<b>AMENDMENT OF SOLICITATION/MODIFICATION OF CONTRACT</b>			1. Contract Number	Page of Pages 1   1
2. Amendment/Modification Number DCAM-2008-B-0014-001	3. Effective Date 11/14/2007	4. Requisition/Purchase Request No.	5. Solicitation Caption Eastern Market Rehabilitation

**ADDENDA NO. 1****EASTERN MARKET REHABILITATION**

IFB No. DCAM-2008-B-0014  
 225 7<sup>th</sup> Street SE  
 Washington, DC

**THE DOCUMENTS DATED 19 SEPTEMBER 2007 SHALL BE AMENDED AS FOLLOWS:**

PROJECT NO. EA710B
BLDG ID NO. 47
DATE: 14 NOV 2007
DRAWING NUMBER K1,K6,D11/P104

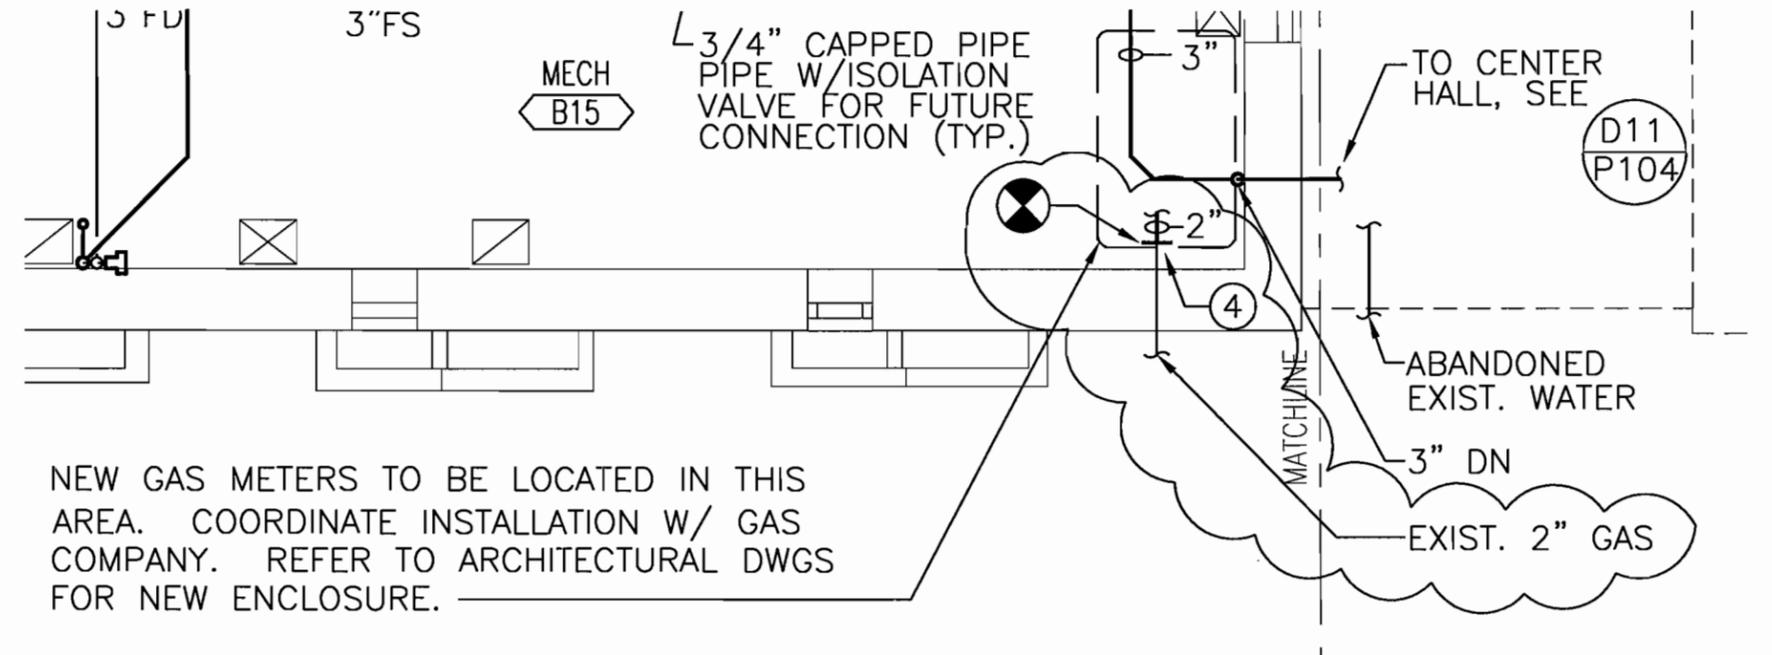
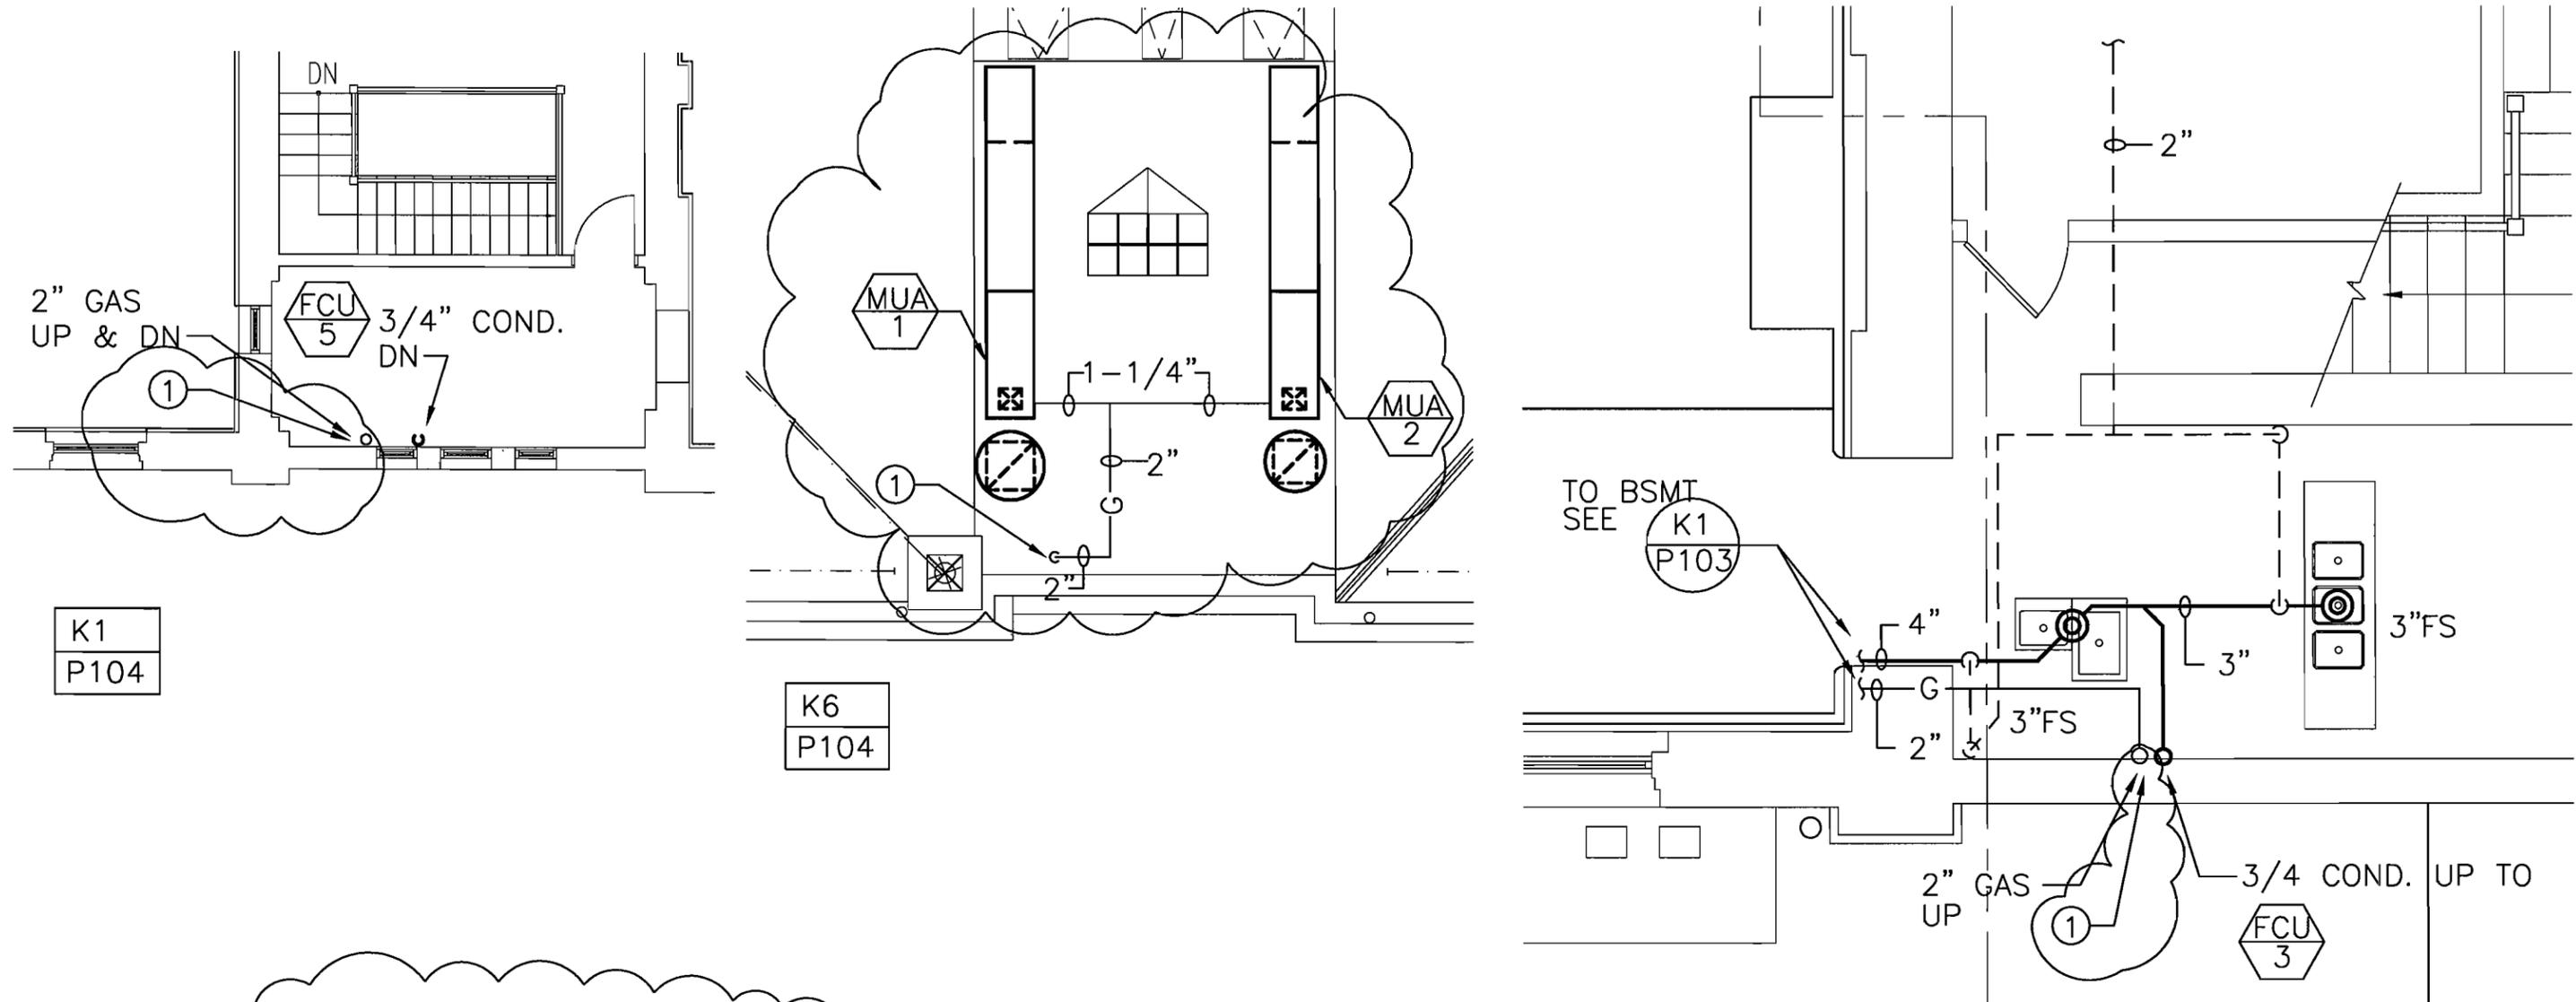
P104	<p><b>Revise</b> drawing P104, as described below and <b>per attached detail, K1,K6,D11/P104, dated 14 Nov 2007.</b></p> <ol style="list-style-type: none"> <li>1. At K1, <b>add</b> key note 1.</li> <li>2. At K6, <b>revise</b> gas piping layout for rooftop exhaust fans and make up air units and <b>add</b> key note 1.</li> <li>3. At D11, <b>add</b> key note 1.</li> <li>4. <b>Add</b> Key Note 1 that reads “See A1/M502 for Gas Riser Diagram.”</li> </ol>
P501	<p><b>Revise</b> drawing A1 Sanitary Riser Diagram at grid location P15 to remove plumbing fixture P-4 and associated vent and waste lines; <b>see attached detail, A1/P501, dated 14 Nov 2007.</b></p>
P502	<p><b>Revise</b> drawing A1 text “Elevator Sump Pump” at grid location G6 to read “Sewage Ejector Pump”, and <b>add</b> cleanout, <b>as indicated on attached detail, A1/P502, dated 14 Nov 2007.</b></p>
P503	<p><b>Revise</b> drawing B1, as described below and on <b>attached detail, B1/P503, dated 14 Nov 2007.</b></p> <ol style="list-style-type: none"> <li>1. At grid locations Q3 – <b>revise</b> indicated piping size from 1/2” to 3/4” on Plumbing Water Riser Diagram.</li> <li>2. At grid location Q13 – <b>revise</b> Plumbing Water Riser Diagram to remove plumbing fixture P-4 and associated supply line.</li> </ol>

- ① PROVIDE 1" TRAPPED DRAIN @ BOTTOM OF OA INTAKE PLENUM & DISCHARGE TO NEAREST FLOOR DRAIN W/AN AIR GAP.
- ② 3" CAPPED GAS PIPE FOR CONNECTION BY OTHERS. NEW CONNECTIONS SHALL BE SUBMETERED & COORDINATED W/GAS COMPANY.
- ③ 3/4" HW MAKE-UP, SEE M501.
- ④ SEE A1/M502 FOR GAS RISER DIAGRAM

**2/E104**

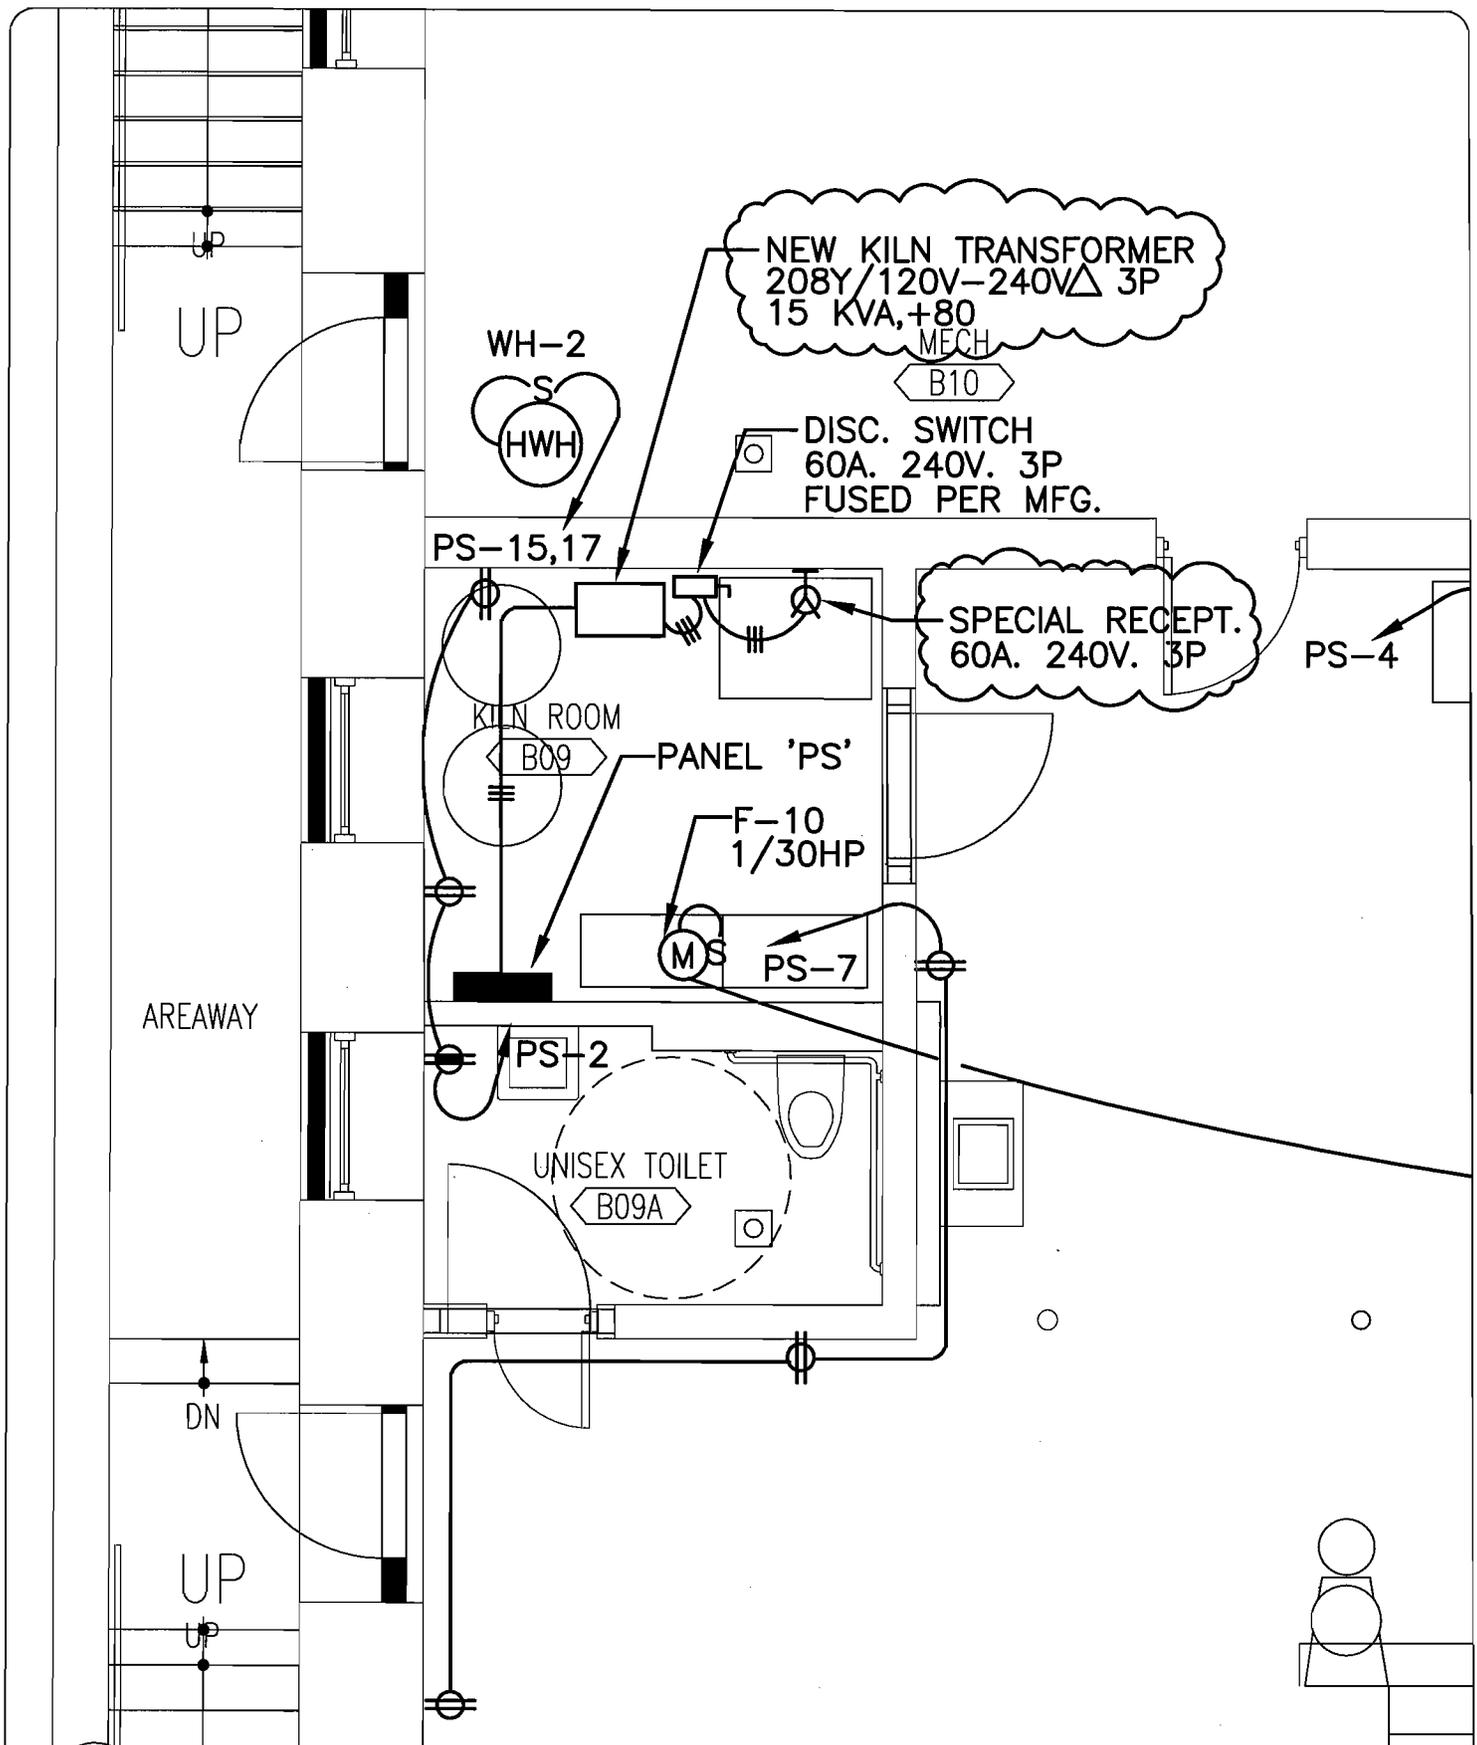
E103	<p><b>Revise</b> drawing 2 to read “See Raceway Detail on Sheet E701” at grid locations B8 and E6; <b>see attached detail 2/E103, dated 14 Nov 2007.</b></p>
E104	<p><b>Revise</b> drawing 2 to provide motor and disconnect switch requirements per <b>attached detail 2/E104, dated 14 Nov 2007.</b></p>

PROJECT NO. EA710B
BLDG ID NO. 47
DATE: 14 NOV 2007
DRAWING NUMBER <b>1/E122</b>

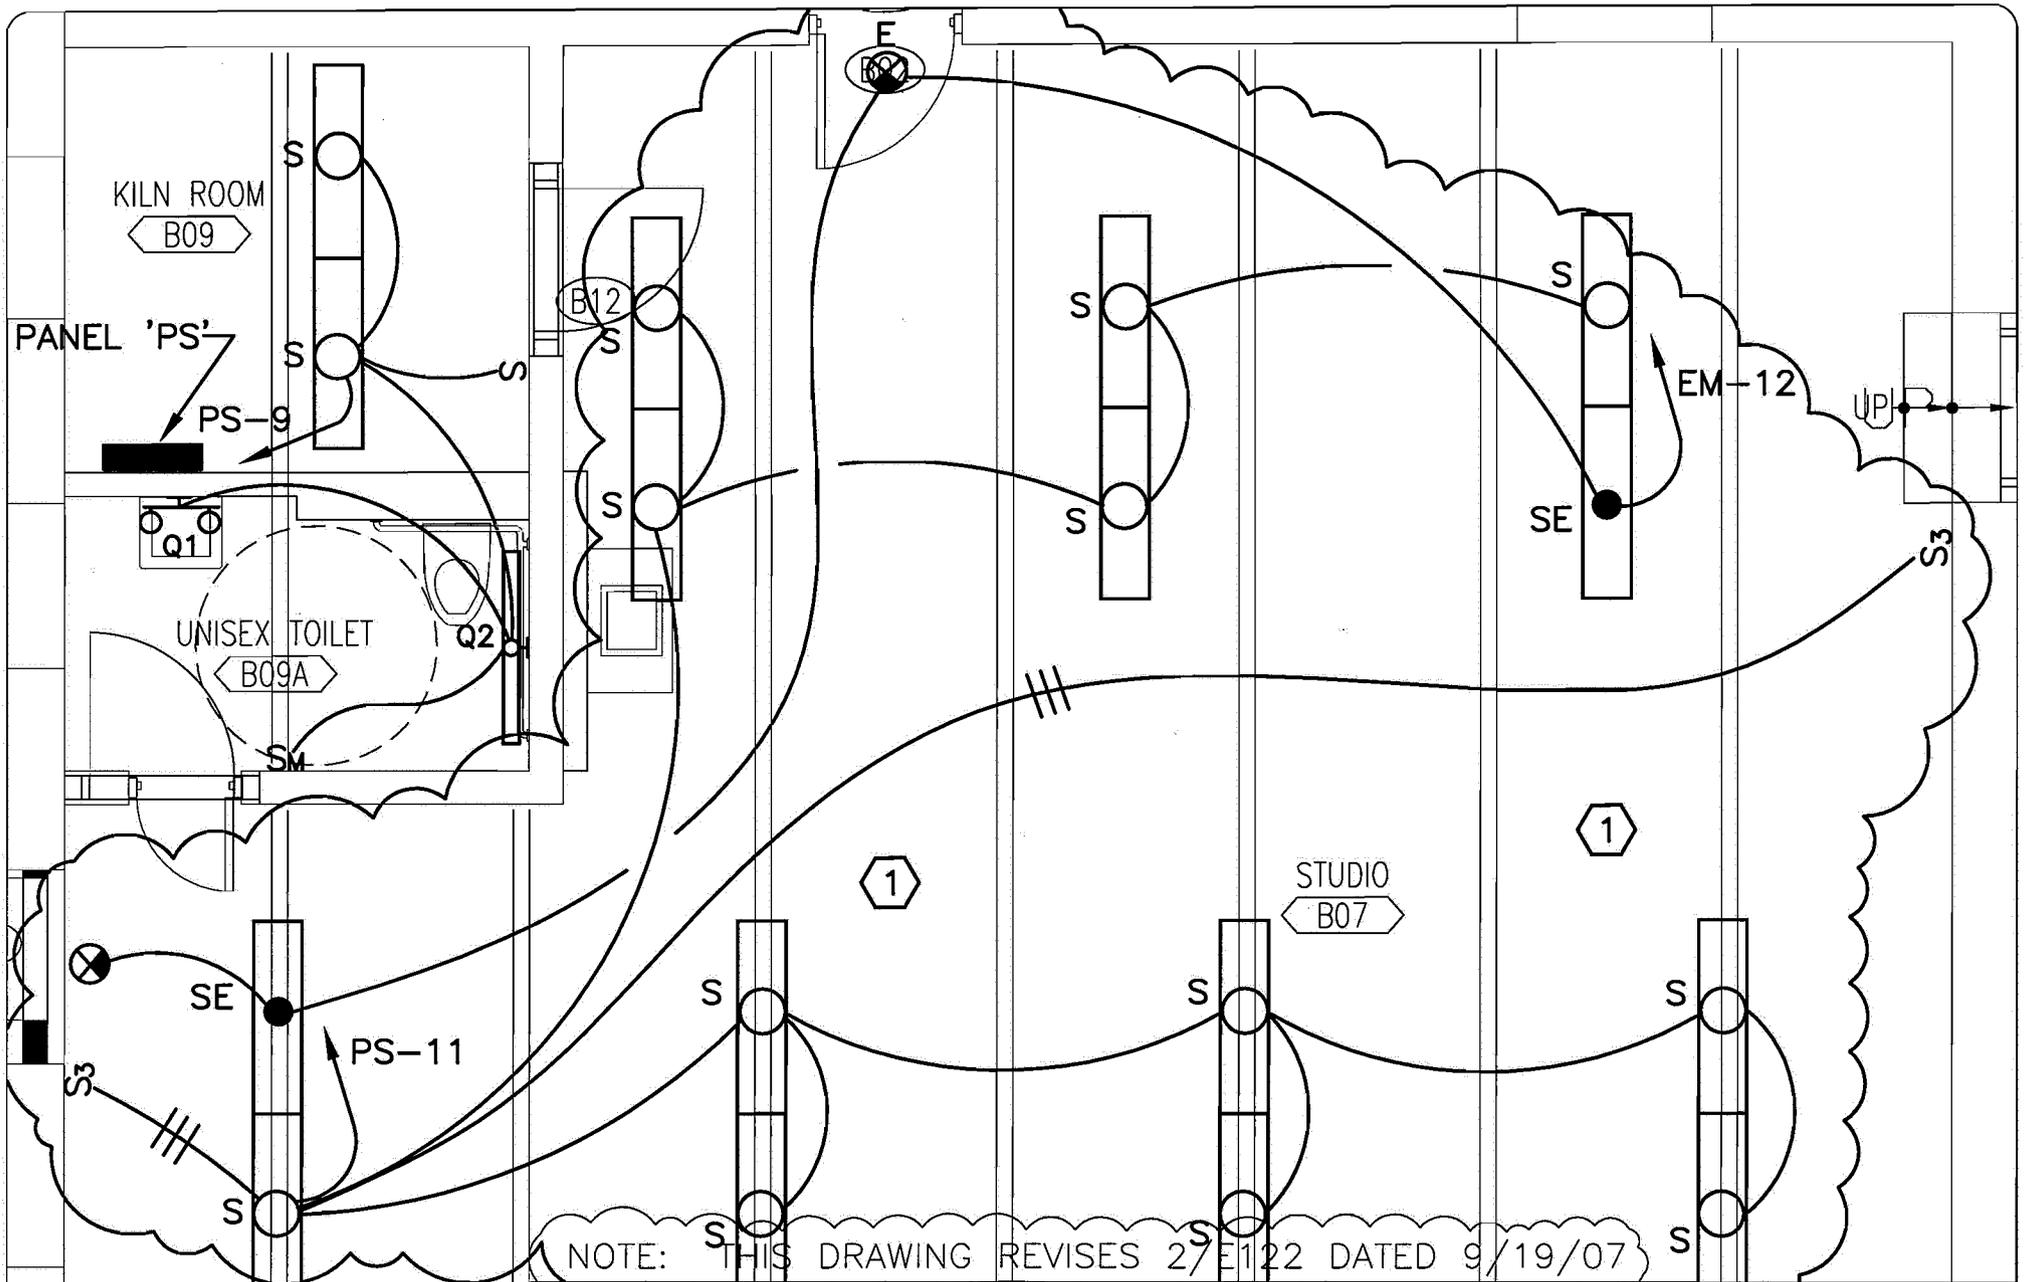
Sheet No.	Change:
E122	<u>Revise</u> drawing 1 to provide a special receptacle and to revise the new kiln transformer requirements at Room B09 per <b>attached detail 1/E122, dated 14 Nov 2007.</b>
E122	<u>Revise</u> drawing 2 to put emergency lighting on emergency circuit per <b>attached detail 2/E122, dated 14 Nov 2007.</b>
E601	<u>Revise</u> drawing 1 to include layout dimensions for new power distribution equipment per <b>attached detail 1/E601, dated 14 Nov 2007.</b>
E602	<u>Revise</u> drawing 2 "New Power Riser Diagram", as described below and per <b>attached detail 2/E602, dated 14 Nov 2007.</b> <ol style="list-style-type: none"> <li>1. At grid locations D8 and F9, to provide feeder and conduit size.</li> <li>2. At grid location D13, to omit the FACP disconnect switch.</li> <li>3. At grid location J11, to provide requirements for panel 'MDP2'.</li> </ol>
FA103	<u>Add</u> drawing "Fire Alarm Annunciator Panel" per <b>attached detail FA103, dated 14 Nov 2007.</b>
